CITGO Petroleum Corporation

RE: Comments on EPA NPDES Draft Permit MA0004782 and Massachusetts Permit to Discharge Pollutants to Surface Water (MA Permit No. MA0004782)
CITGO Petroleum Corporation, Braintree Terminal
385 Quincy Avenue, Braintree, MA

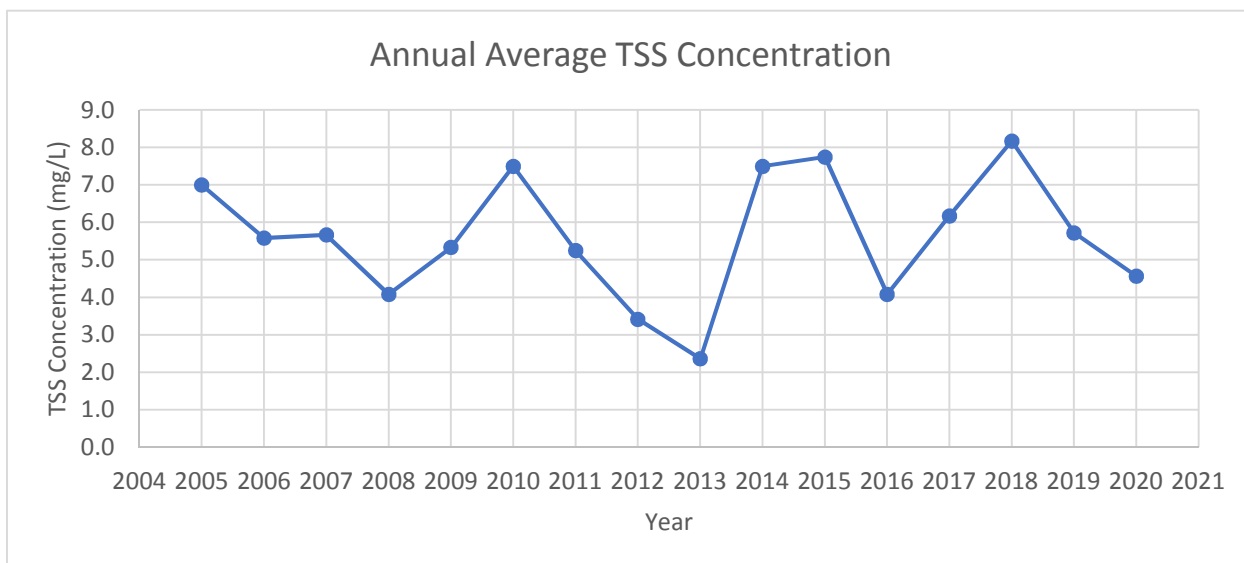
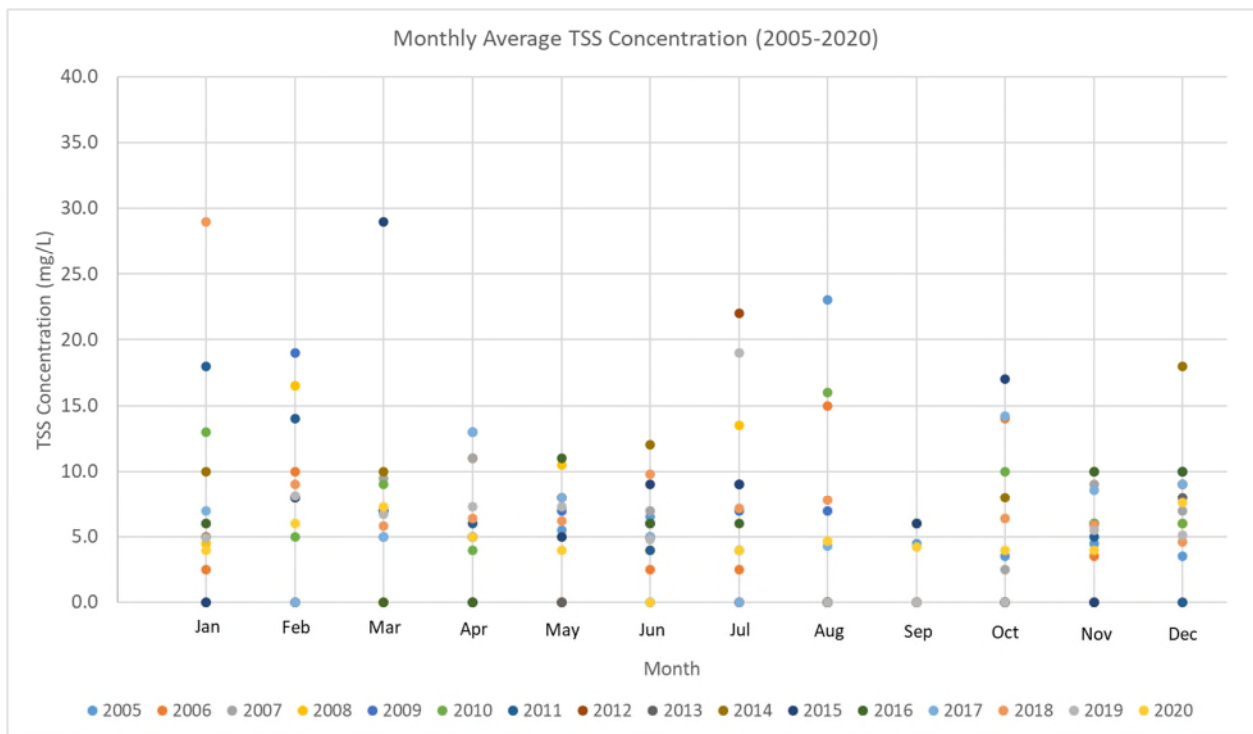
The Draft Permit increases the sampling frequency for TSS at Outfall 001 from 1/month in the 2008 Permit to 2/month. As described at pages 19-20 of the Fact Sheet, EPA believes that the increased sampling is necessary to provide additional data to calculate a TSS concentration more representative of the monthly average value and is consistent with the requirements at other terminals in Massachusetts. CITGO takes exception to the increased

The TSS results from Outfall 001 over the past 16 years have averaged 5.6 mg/L per month (see figure below for the annual means from 2005 to 2020, the data from February 2013 is excluded). Also, there were 59 months in which the TSS discharge was 0 mg/L which is an average of nearly 4 months per year. There is no justification to increase TSS sampling just to show that it is non-detect during one third of the sample events every year.

CITGO requests that the TSS monitoring and reporting requirement for Outfall 001 remain 1/month as in the 2008 permit.

Hydrogen ion concentration as pH from measurements made at the Central Analytical Laboratory, 2018

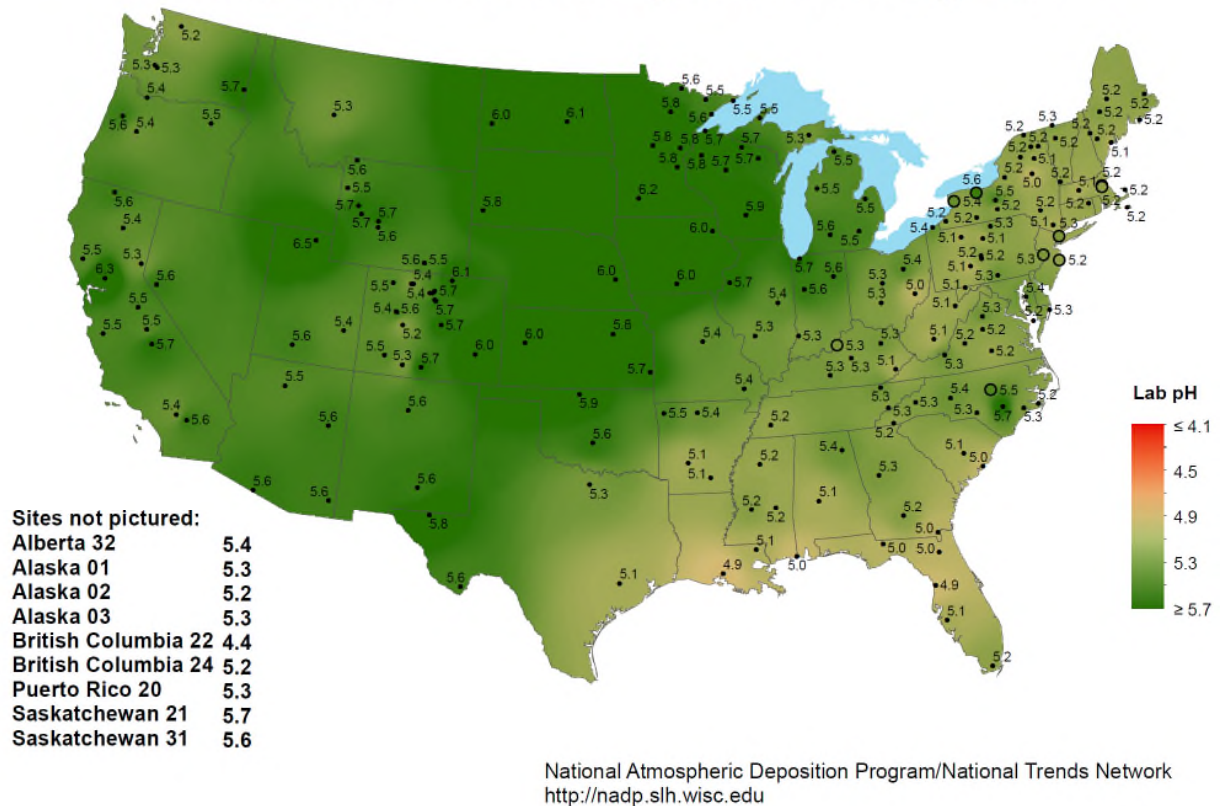
In addition, although the discharge from the Facility has historically met the discharge limits for pH, CITGO is concerned about the more stringent discharge limits for pH in the Draft Permit. National Atmospheric Deposition Program ("NADP") data shows that rainwater in the New England region often has a pH below the proposed discharge limitation of 6.5-8.5 S.U. Based on the NADP data, it appears that rainwater in New England contains pH levels below 6.0 S.U. The following figure shows the 2018 annual pH map of the U.S. The data from other years perform similarly. The monthly average of pH in rainfall in Massachusetts based on the NADP data collected from 1985 to 2018 is approximately 4.7 S.U.

As the Facility is a petroleum storage and distribution facility, there are no processes on site that alter pH. It appears that some level of natural buffering occurs, resulting in pH in stormwater above 6.0 S.U., due to contact with soils and impermeable surfaces at the Facility. However, as this natural buffering is limited and outside the control of CITGO, EPA should acknowledge that the pH of rainwater in this area is acidic, and that this is a natural condition that impacts the stormwater discharge.

CITGO also requests that the Draft Permit include that a discharge below 6.5 S.U. that can be attributed to sampling of rainwater will not constitute a violation.

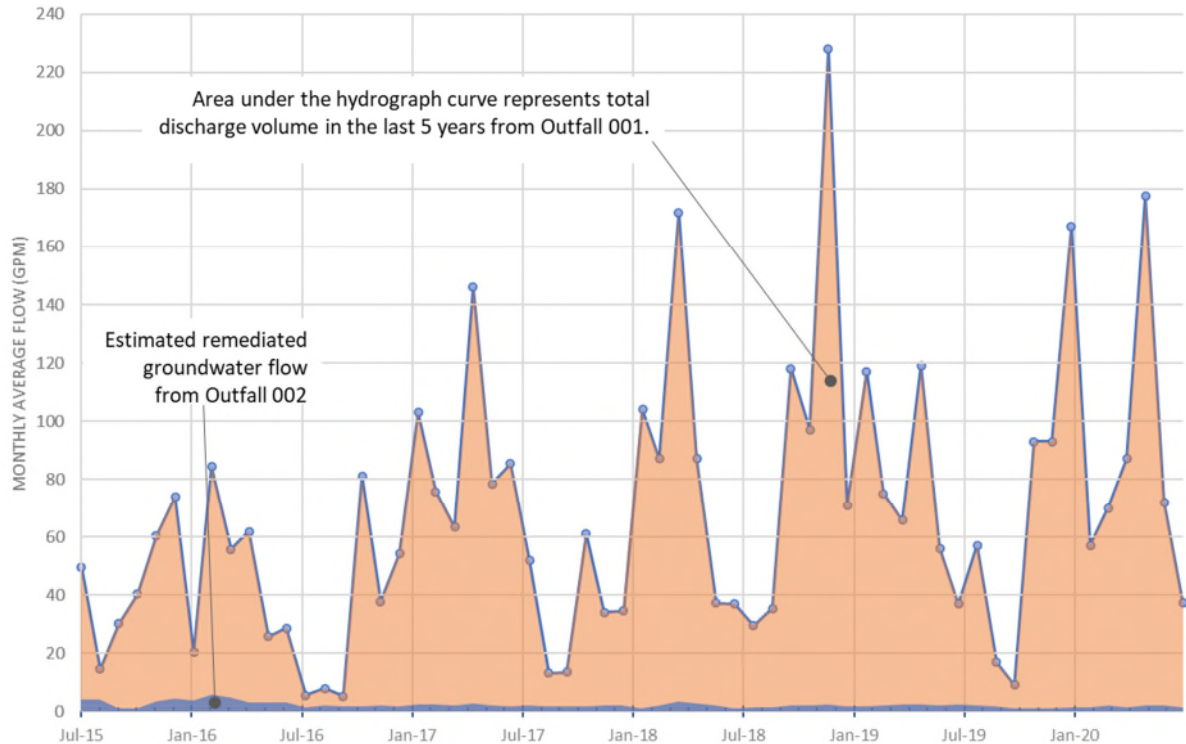
The figure below plots the average monthly flow from Outfall 001 in the past 5 years with the area under the hydrograph curve representing the total volumes (175 million gallons). Based on the reported average monthly flow from the groundwater remediation system, the discharge from Outfall 002 is approximately 5.84 million gallons. Discharge from Outfall 001 is predominately stormwater runoff that counts for more than 96% of the total flow. Therefore, best professional judgement should categorize the discharge as stormwater runoff and regulate its water quality accordingly.

As the Weymouth Fore River is not impaired for benzene, CITGO requests that EPA revise the effluent limit for benzene to 51 µg/L, which is fully protective of the receiving water body and is (1) supported by EPA’s 2015 Updated Human Health Criteria; (2) consistent with the 2008 Permit; and (3) consistent with MassDEP’s proposed standards (16 µg/L to 58 µg/L).
